Drawing Number **AEL-19354**

Client **Alder Mill**  
Project **Mayfield, Sibson**

Title **TIP - Tree Impct Plan**  
Scale **1:250** Date **16/12/2025** Drawn **RJH** Checked **RJH** Drawing No. **A**

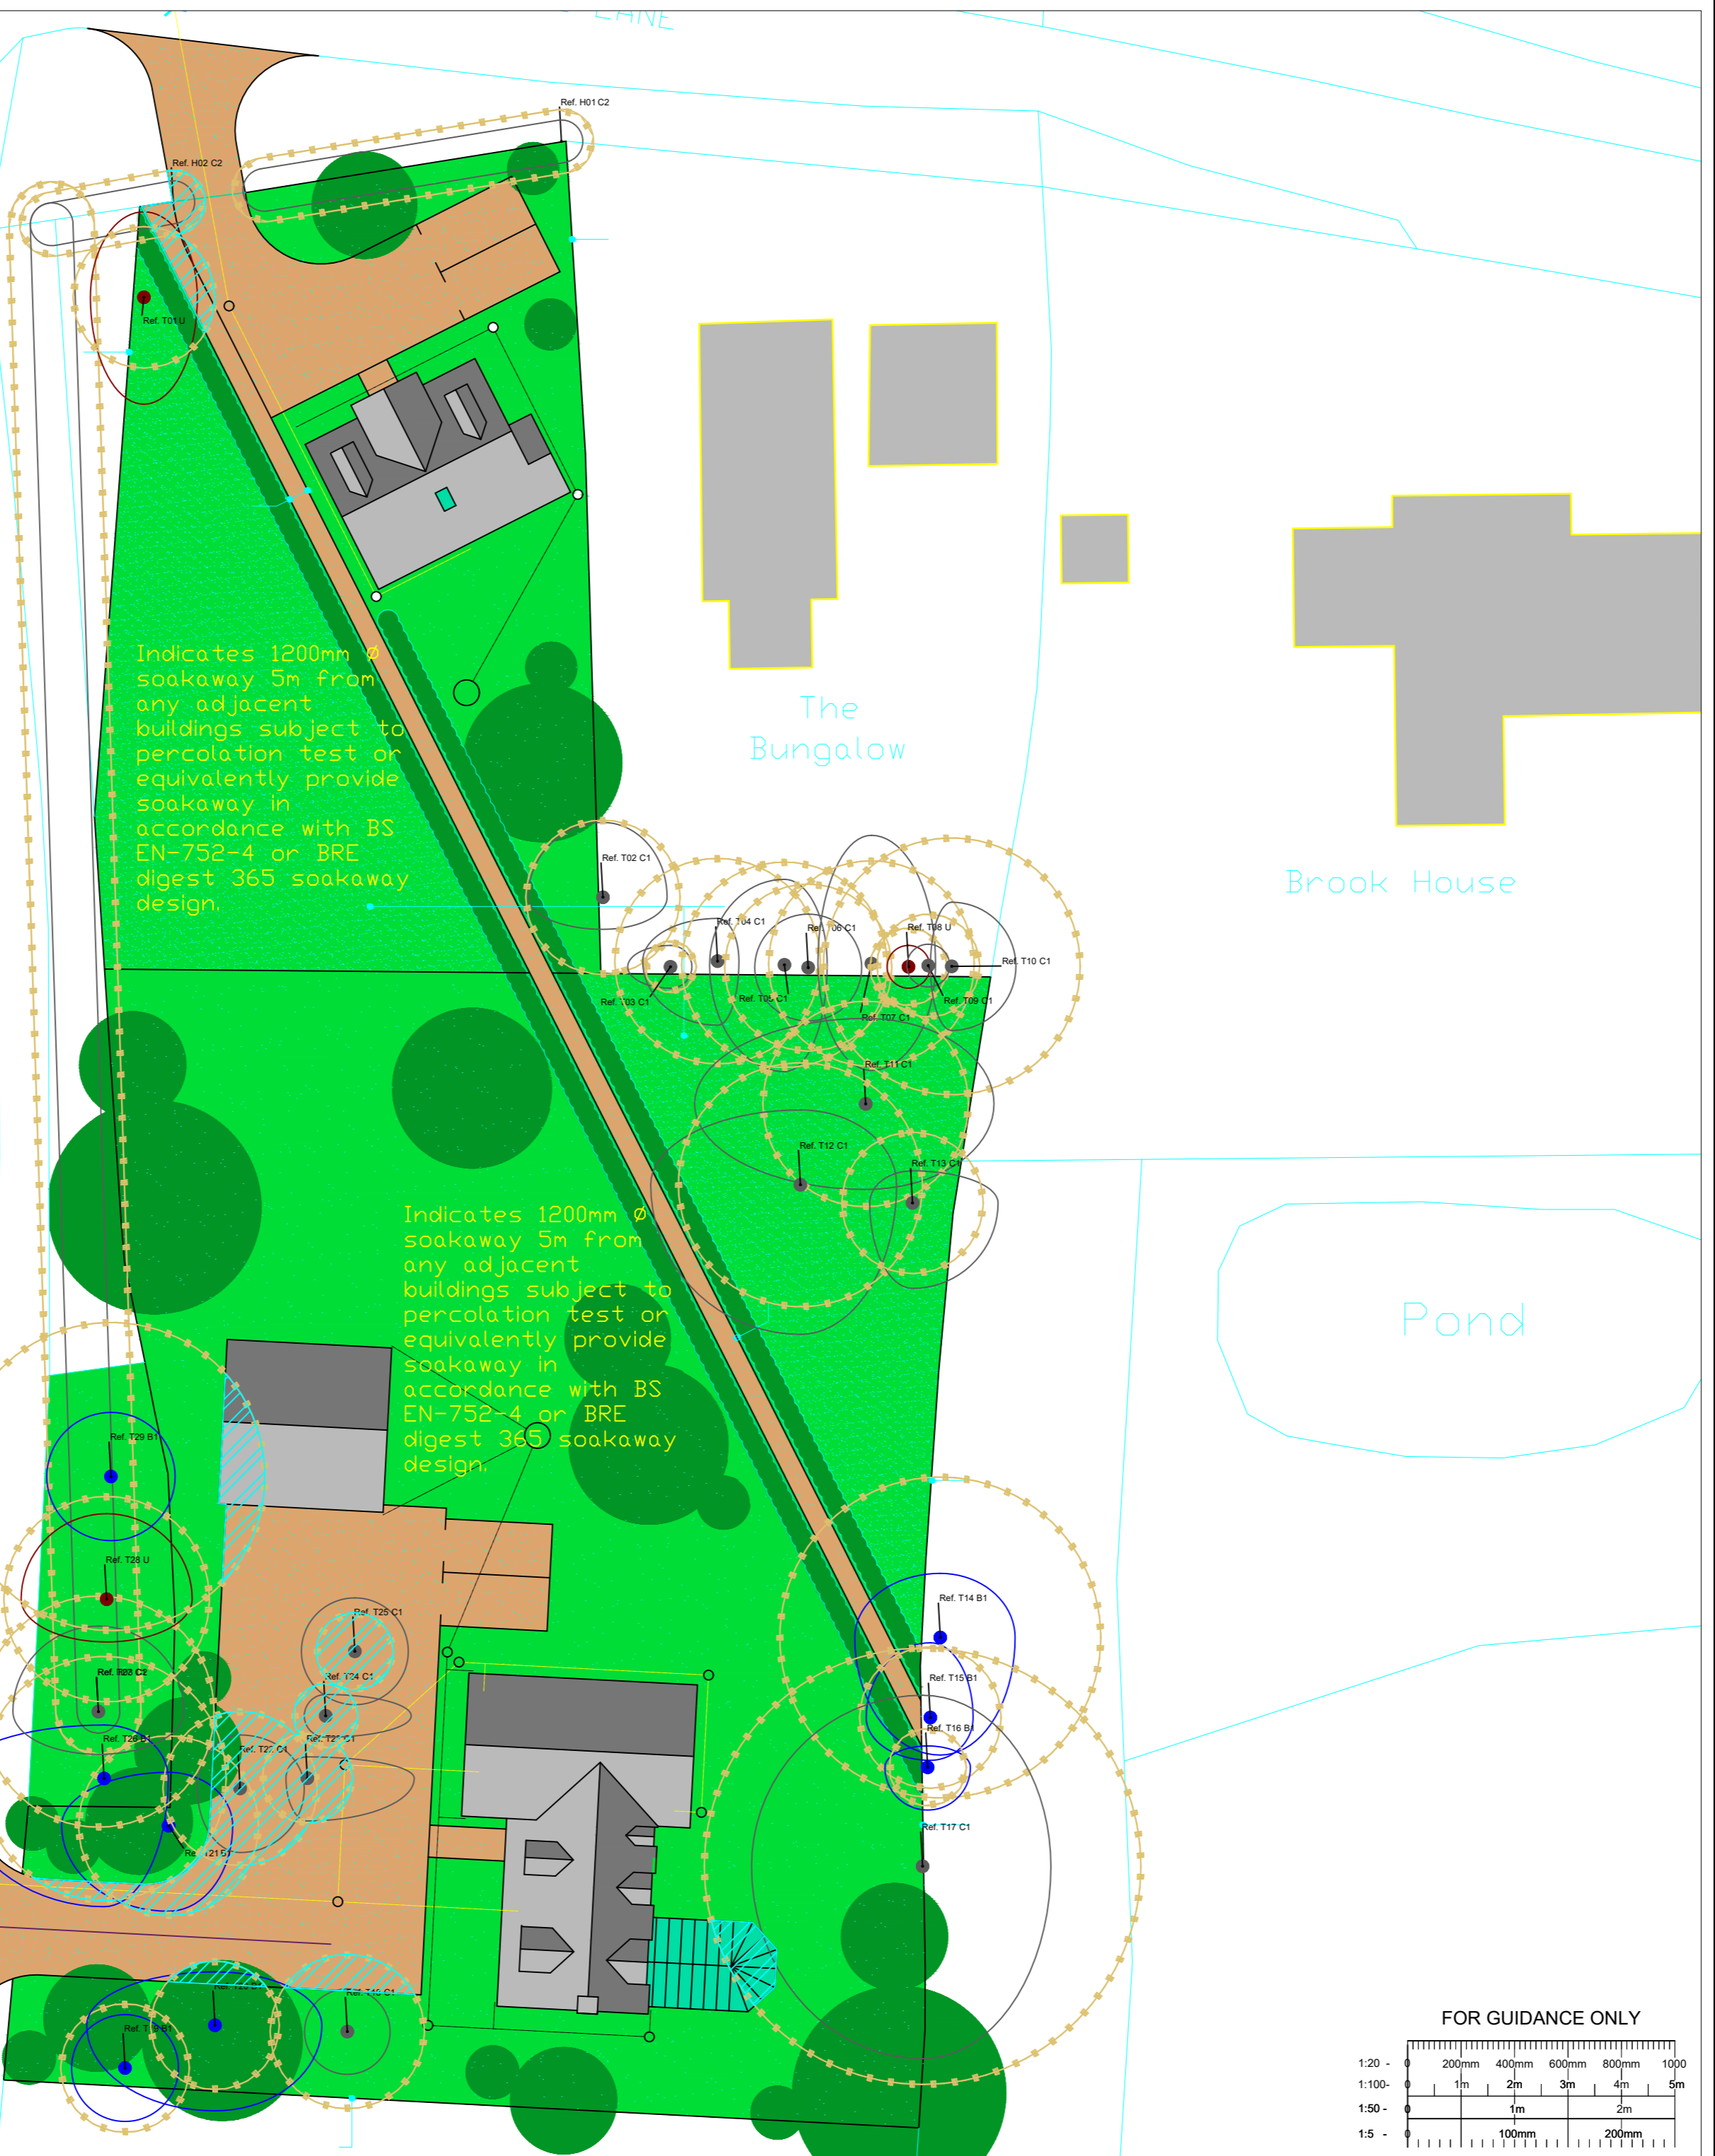
Arboricultural comment:  
Move foul and services by 2000mm south of original route, outside of RPAs
